Composite Design, Inc.  
1136 Pinelake Drive  
Townville, SC 29689  
U.S.A.

**Date: 5 June 2023**

**Subject: Composite Design manufactured control panel for all UL engines**

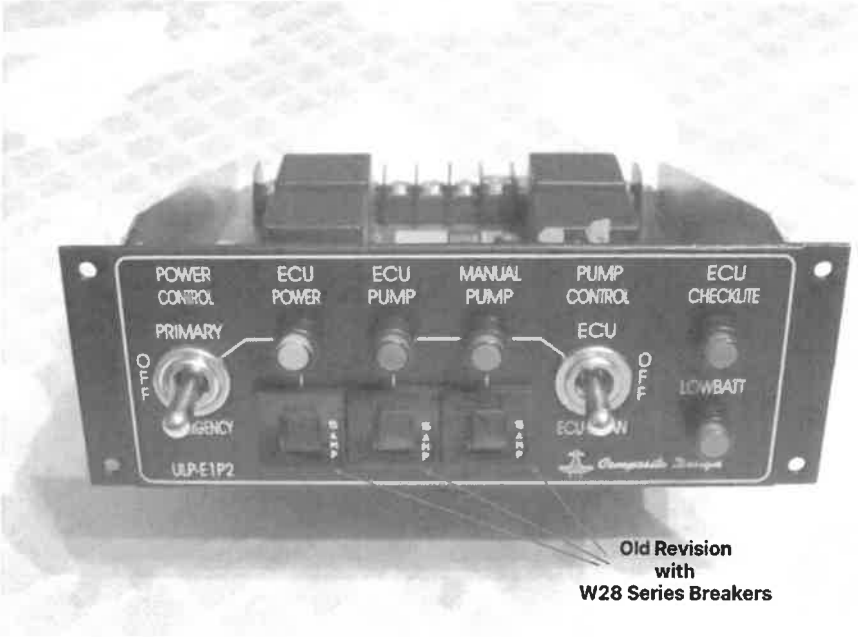
Several customer have had a loss of ECU power due to an undetermined issue with the 20A ECU breaker. Stress analysis on several breakers indicated that the breakers performed per manufactures specifications using a static DC load. In actual operation with the engine several of the 20A breakers tripped causing loss of engine power. The breakers in question are from Tyco electronics - model# W28-XQ1A-20.

A revision to the UL control panels several years ago has mitigated this issue. Many of the panels fitted with the W28 series breakers are still in the field or in aircraft under construction. The new breakers have been supplied with the UL control panels for the past two+ years with no operational problems. The newer breakers are Klixon (Sensata) series 7277 or 7274 series, easily identified as having a pullable knob type actuator.

It is highly recommended that all existing control panels with the W28 series circuit breakers be refitted by Composite Design with the new breakers. This is a factory modification only.
